Re: Carter Becker, Shore Drive (Map 5, Lot 96A)- Response to Sebago Technics Report

We are in receipt of the project review report (“Report”) prepared by Sebago Technics (“Reviewer”), dated July 23, 2024, purportedly acting as an independent reviewer on behalf of the Commission. Our responses are in the same order as noted in the Report.

# **Work Plan**

## **Temporary Boat Launch Ramp**

REVISIONS			
REV.	BY	DATE	DESCRIPTION
0	RAC	05/12/24	PROFILE

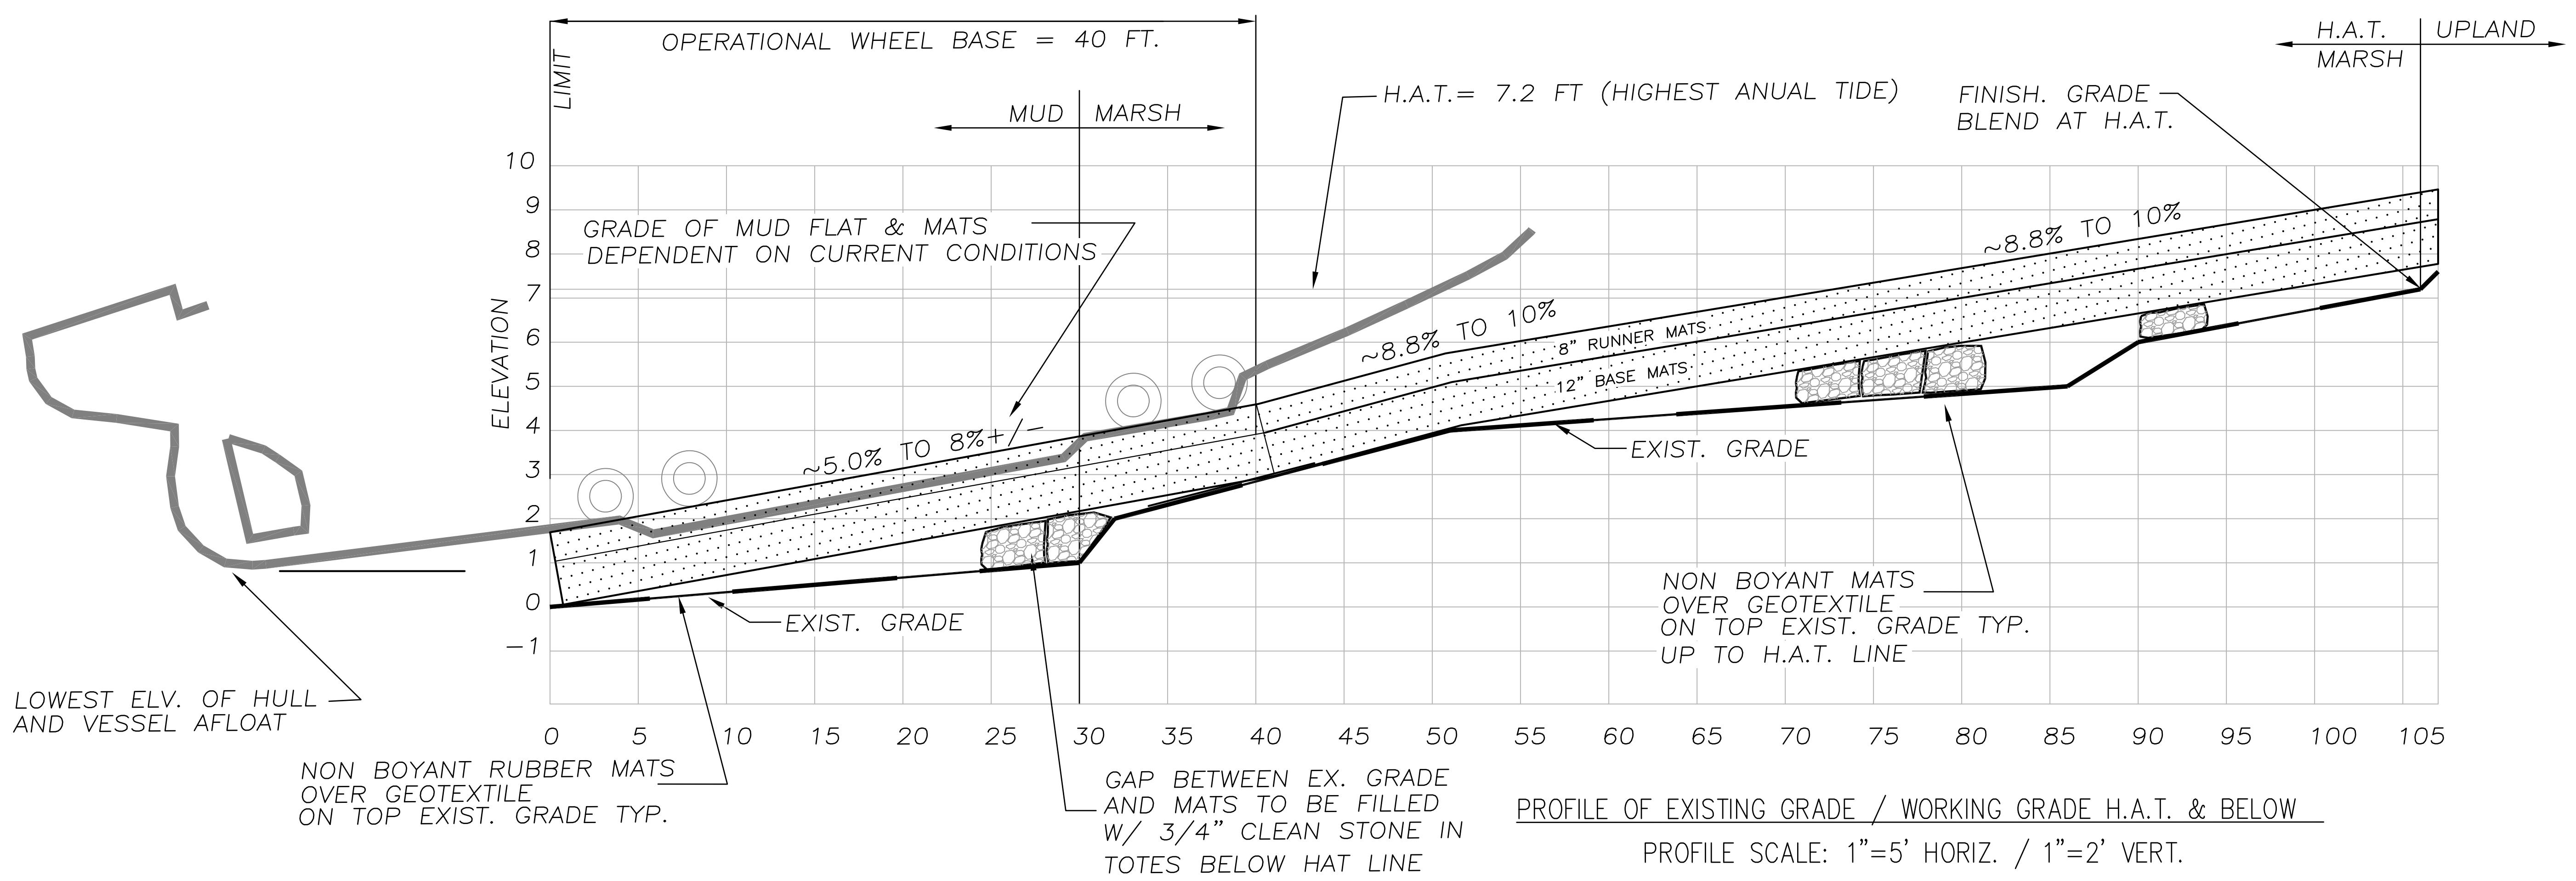
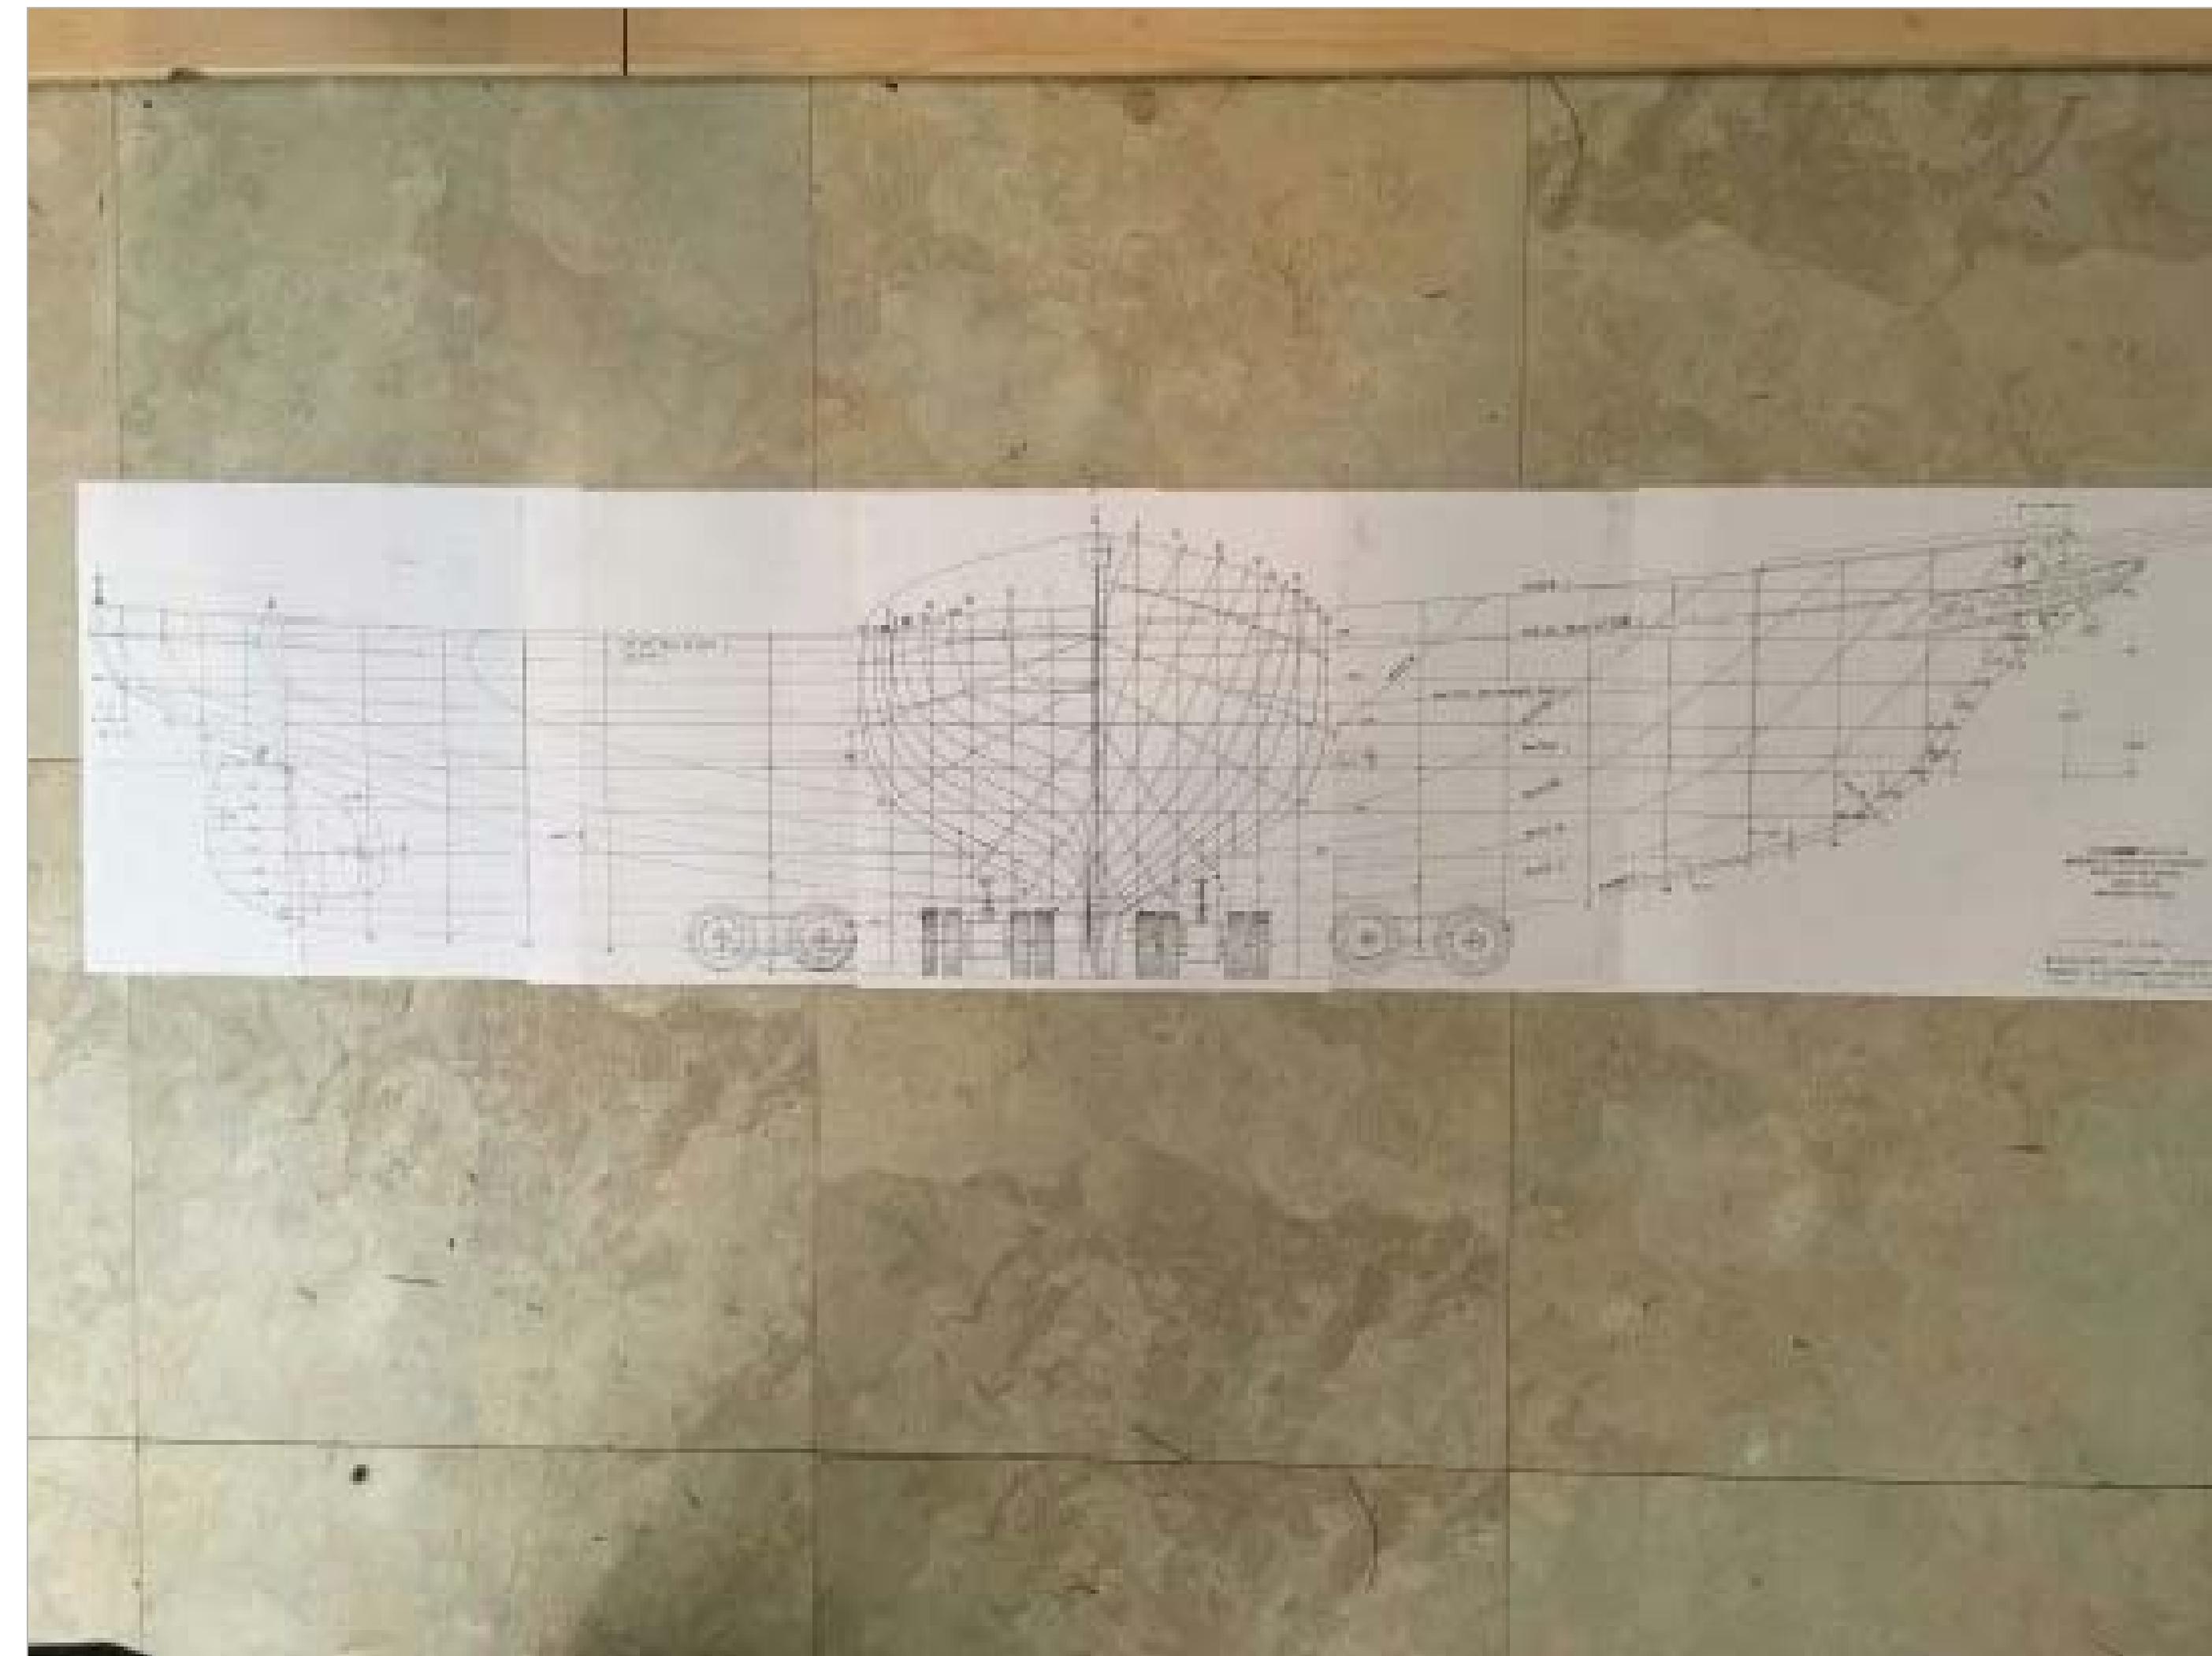
2. The Reviewer requests a scaled profile of the access road as it may be helpful to understand, in part, the water available for the floatation of the vessel. A scaled profile plan is provided and attached to this response. The profile plan provides a

4. The Reviewer requests that the applicant provide the vessel profile and vessel carrying system on the profile plan requested in #2, above. This has been included in the attached profile plan. The profile plan demonstrates that the 40' long project terminus is sufficiently sized for the vessel and its carrying system components. Plans depicting the locations of floatation bags have been provided to the Commission previously, although the floatation system design again is not within the Commission's scope of review.
5. The Reviewer recommends that a geotechnical engineer review the site conditions and the calculations that have been provided by the design engineer. The project was designed by a Licensed Professional Engineer according to accepted engineering

more detailed construction design for the temporary boat launch ramp. A scaled depiction of the vessel is included on the plan. We respectfully disagree that vessel floatation is within the Commission's jurisdiction. The Commission members may be interested in floatation details as a matter of personal interest; however, the floatation design is neither required nor addressed by the ordinance standards and is not subject to review for this application.
